SUBJECT: NuScale Power, LLC Response to NRC Request for Additional Information No. 167 (eRAI No. 8964) on the NuScale Design Certification Application

REFERENCE: U.S. Nuclear Regulatory Commission, "Request for Additional Information No. 167 (eRAI No. 8964)," dated August 12, 2017

NRC Question No.: 03.08.05-2

Figure 1 - Edge and Center Nodes at Bottom of Foundations Selected for Building Settlement Assessment

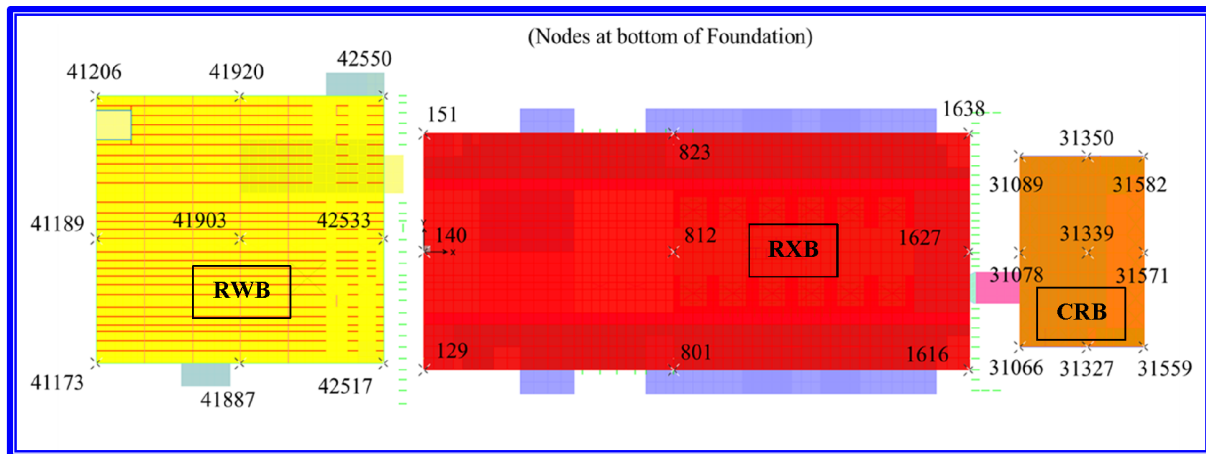
In FSAR Tier 2, Section 3.8.5.6.7, “Basemat Soil Pressures along Basemat Edges (Toe Pressures),” the applicant performed analyses to determine the edge bearing pressures (or toe pressures) along the edges of the seismic Category I structure basemats (RXB and CRB). In FSAR Tier 2, Section 3.8.5.5.5 “Settlement Approach,” the applicant considered a condition of the soil stiffnesses that are further reduced by 50 percent to amplify the effect of settlements. Therefore, provide information on associated settlements due to soft soil stiffnesses along the edges of the seismic Category I structure.

The foundation displacement results from the static, flexible-base triple building model are presented. The displacements, due to soft soil stiffness, are presented for selected nodes along the foundation edge of the RXB, CRB, and RWB in Table 1 and Table 2 for uncracked and cracked conditions, respectively. The location of the nodes are shown in Figure 1.

The displacement results and associated figure have been added to FSAR Tier 2, Section 3.8.5.
